SUBMISSION OF DETAILS TO COMPLY WITH CONDITIONS
PLANNING PERMISSION F/2001/5260
39 LITTLE GLEBE, SONNING ON THAMES

PROPOSED ERECTION OF SINGLE DWELLING AND CREATION OF VEHICULAR PARKING AREA TO LAND ADJOINING 39 LITTLE GLEBE SONNING ON THAMES - PLANNING PERMISSION F/2001/5260

Location:	39 Little Glebe, Sonning
Proposal:	Erection of detached dwelling with garage and additional garage and parking space for number 39
Application Number:	F/2001/5260

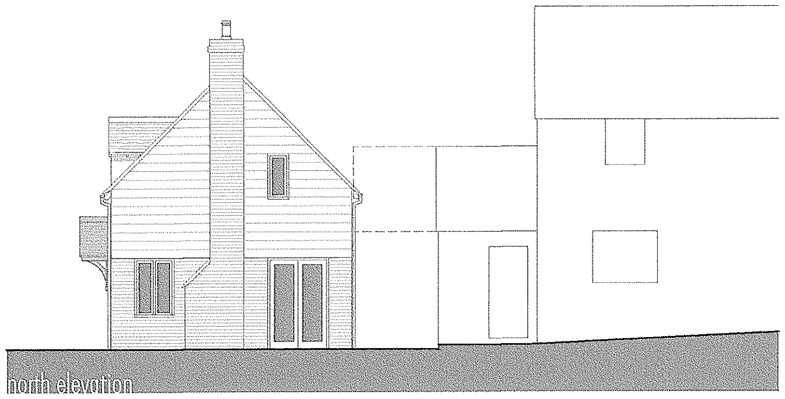
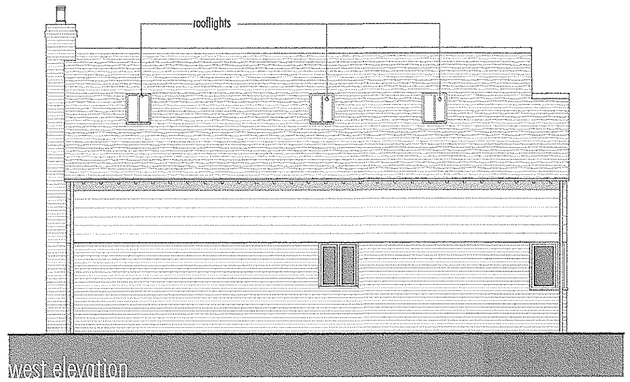
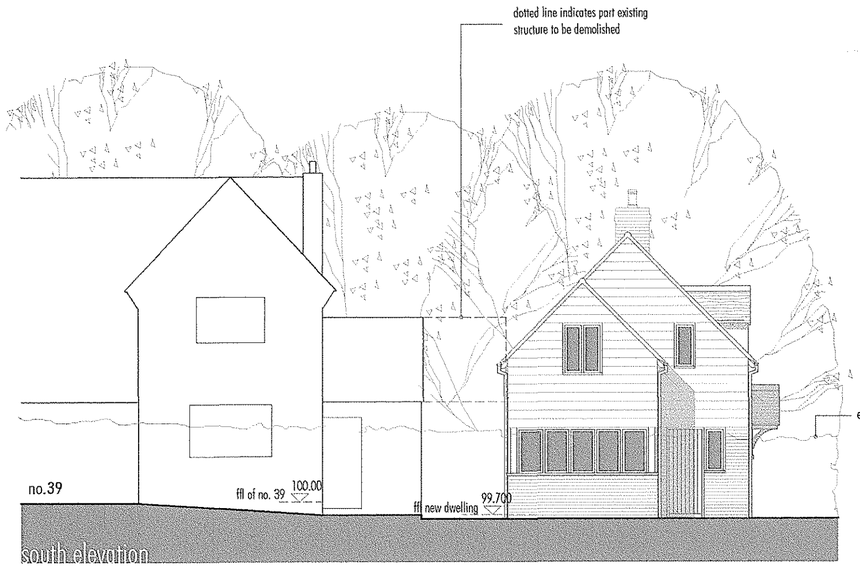
The site is surrounded by Countryside on two sides and currently insufficient planting is shown which will help integrate the development into its surroundings.

- Views into the site from the north will be of car parking and no attempt has been made to screen this area. Shrub planting between the parking area and the boundary would help do this.
- Along this boundary will be found the roots of the horse chestnut trees in the neighbouring field and care should be taken not to damage these roots or interrupt the supply of air and water to them. No details are provided of the car parking surface but it is advised that excavation should not exceed 100 mm and a porous surfacing should be used. The area occupied by the roots is likely to extend approximately 5 metres from the trunks.
- As noted in our earlier comments it may not be possible to retain all of the hedge during the construction period. The drawing should be annotated to the effect that the existing hedge should be reinforced where necessary.
